Amendment Report

Crows Nest TOD State Significant Development (SSD-83076206)

402-420 Pacific Highway, Crows Nest

July 7, 2026

Figure 2: Ground floor plan – submitted and amended (Source: FJC Studio 2026)

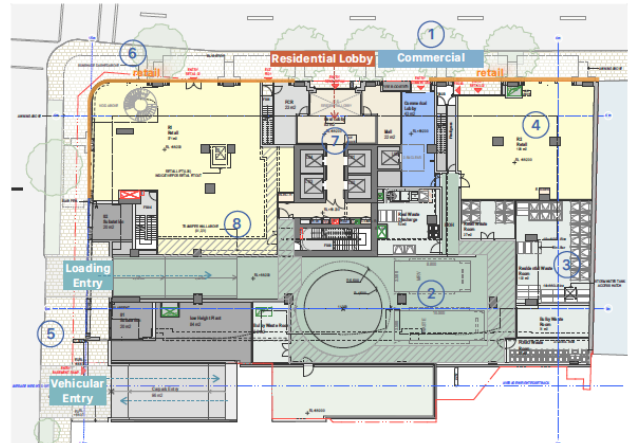
1. Inclusion of commercial lobby from Pacific Highway
2. Revised loading dock, loading vehicle bays
3. Revised waste storage, room split and arrangement
4. Revised retail tenancy - increase floor to floor for Ground to L01
5. Vehicular entries positioned between dual substations for pedestrian safety and urban arrangement
6. Active use and facade maximised, with reduction to services and loading on facades
7. Enlarged residential lobby and facade to street
8. Egress strategy refined with simplified egress points and discharge to streets

Figure 3: Cross section – submitted and amended (Source: FJC Studio 2026)

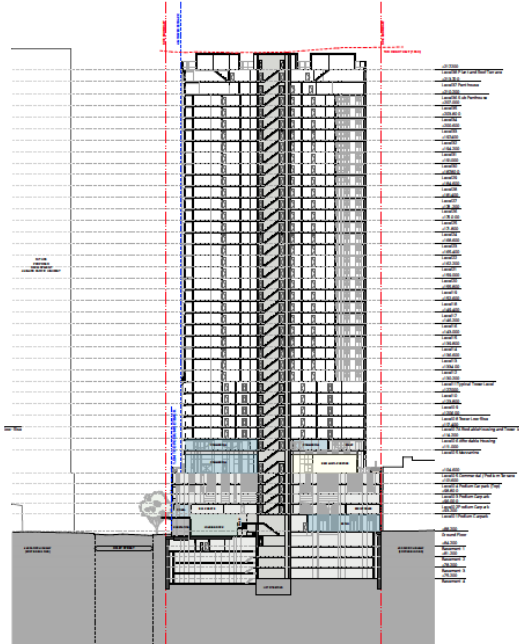
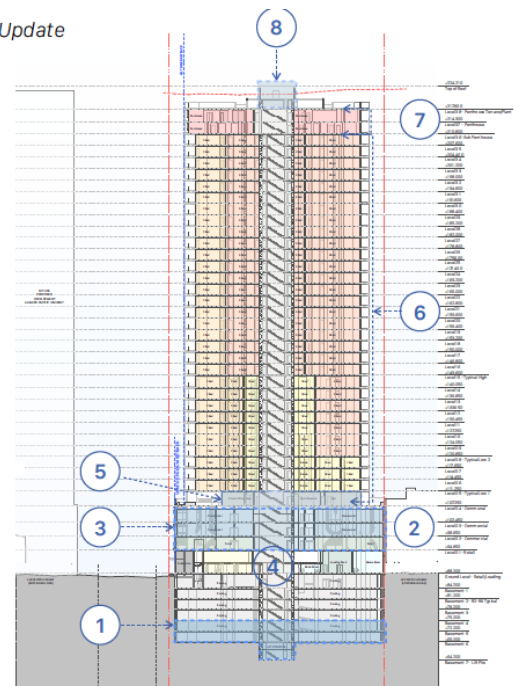
1. Introduction of additional basement levels
2. Removal of all above ground podium parking
3. Increased mixed use in podium / retail at L01, & Commercial at L02 / L03
4. Double height retail ground floor
5. Residential communal open space relocated to L04
6. Revised mix and apartment distribution
7. Penthouses revised with no rooftop access
8. L39 Roof Plant only / slight height non-compliance for lift overrun only (Section 4.6 sought)

Figure 7 Proposed podium setbacks (Source: FJC Studio 2026)

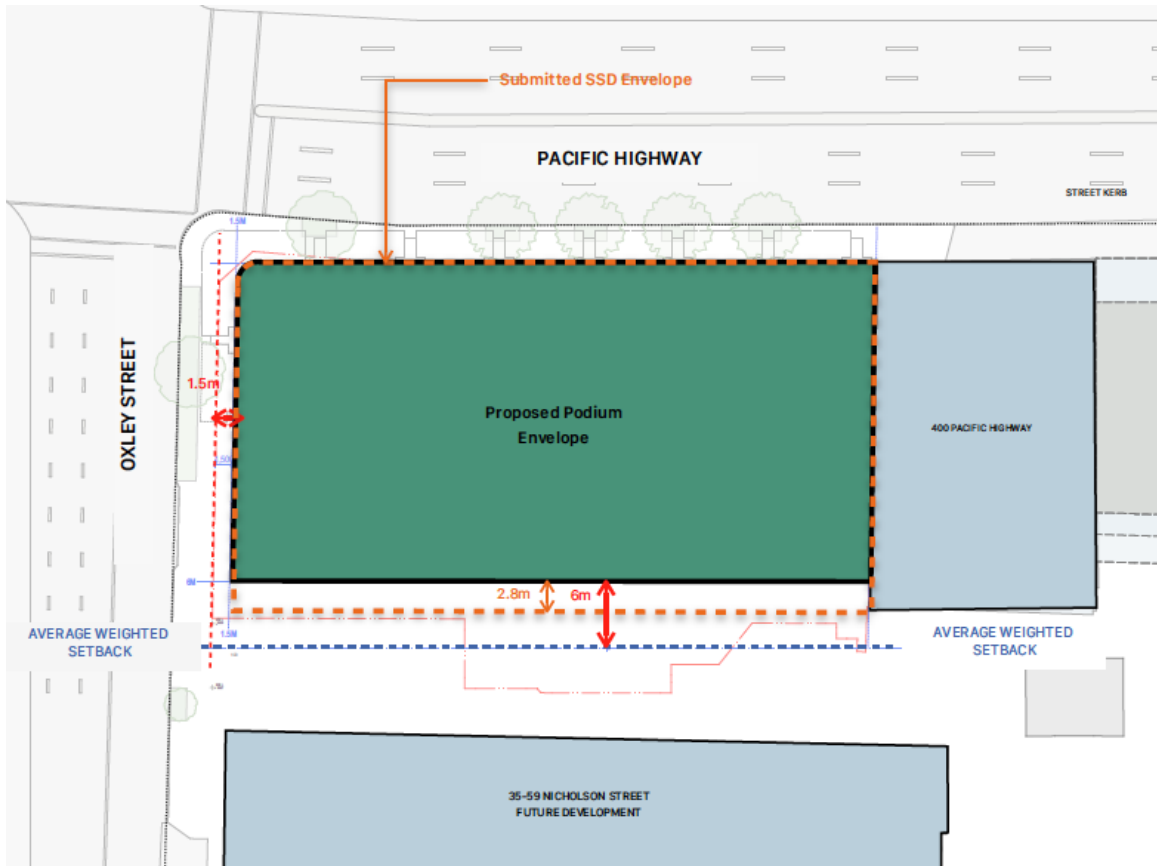
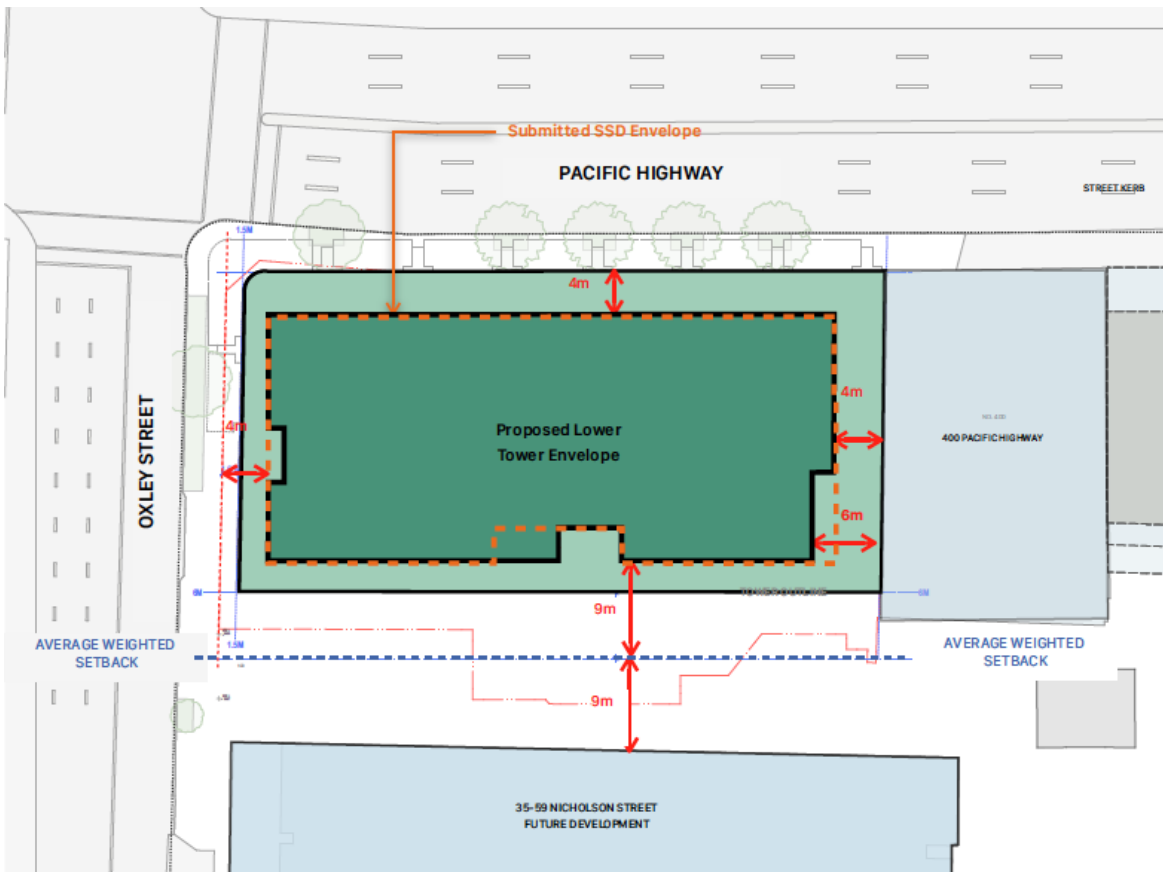
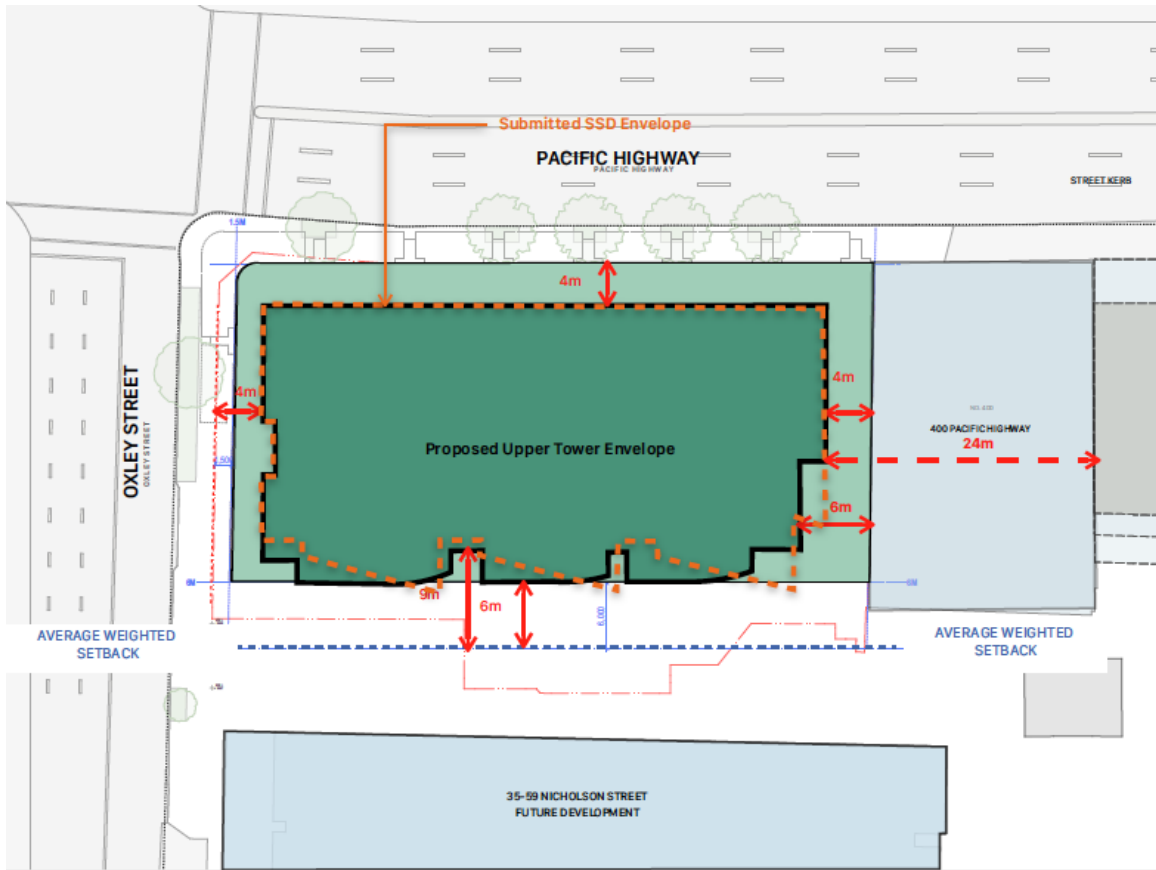
- 9m setback to the weighted average boundary line for the lower levels of the residential tower (level 4 to 14) to accommodate at least 18m separation distance. This provides for an ADG compliant habitable to habitable separation distance for the 5th to 8th storey. The proposed 12th storey of the student housing development aligns with the 10th storey of the proposed development. Up to the 10th storey of the proposed development screening is proposed to enhance amenity and allow for an ADG compliant habitable to non-habitable separation the 9th and 10th storey adjacent to the upper two levels of the student housing.

- 6m-9m setback to the weighted average boundary line for the upper levels of the tower (level 16 and above) which are above the height of the adjacent future development (the high rise tower with reduced setback commences four levels higher than exhibited SSDA).

Figure 10: Height plane diagram (Source: FJC Studio 2026)

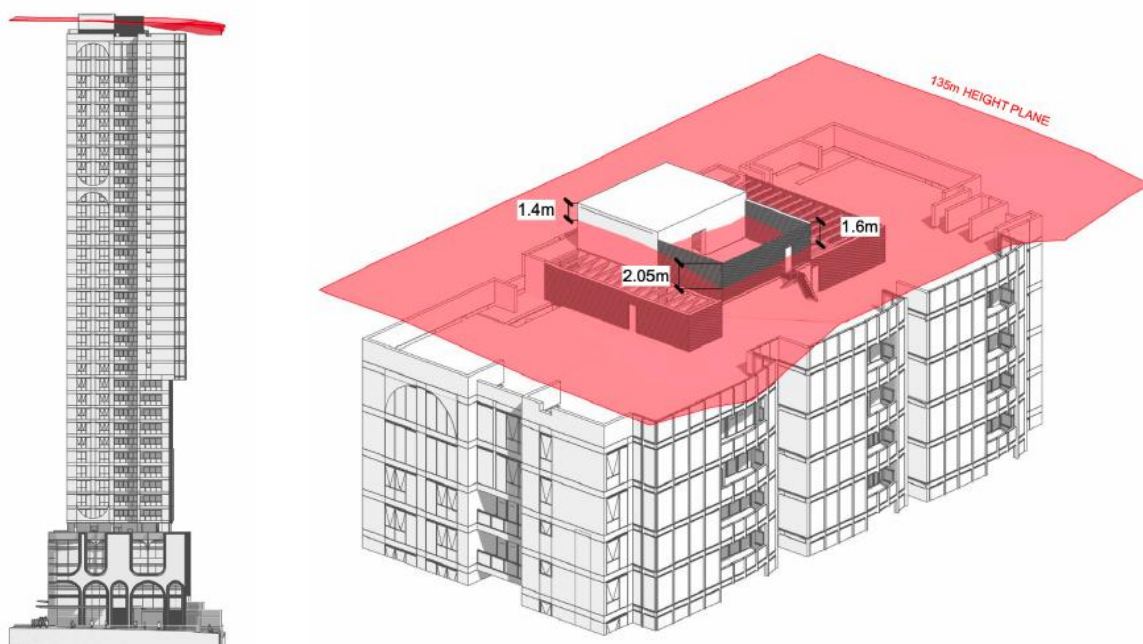
The amended development seeks a minor exceedance of the maximum height of buildings control of 135m to accommodate the upper component of the lift overrun of 1.40m-2.05m (up to 1.5%) as shown at Figure 10 below.

Figure 13: Above podium level wind mitigation measures (Source: RWDI 2026)

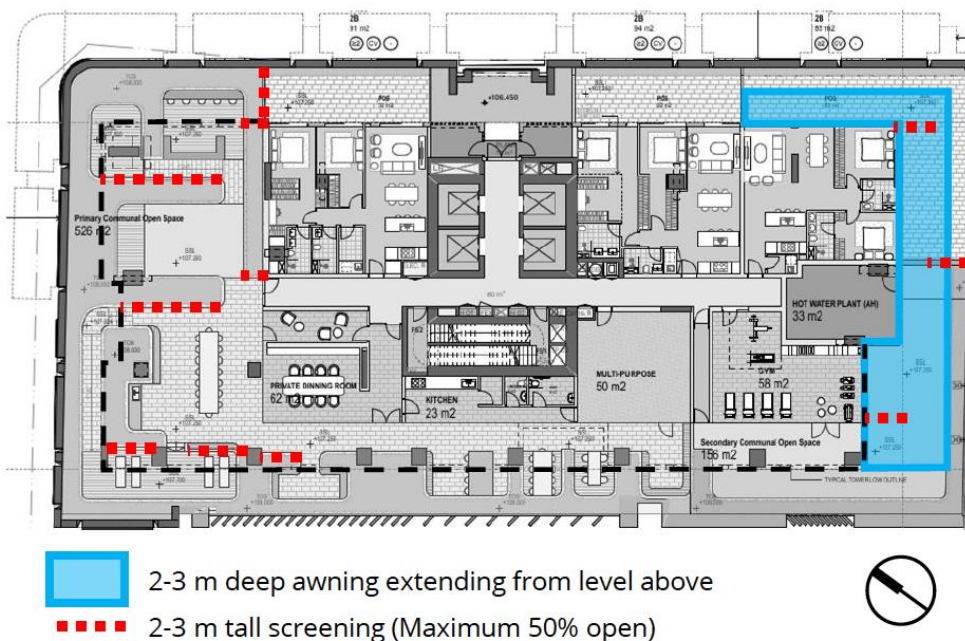
- Podium level mitigation measures (see Figure 13):
 - 2-3 m deep impermeable awning over the southern end of the rooftop terrace wrapping around the eastern corner

- Inclusion of 2-3 m tall screening at the northern and southern ends of the rooftop terrace areas with a maximum porosity of 50%
 - Proposed raised planters and vegetation are recommended to be retained and planted with densely foliating, evergreen and with a minimum total height of 1.5 m.
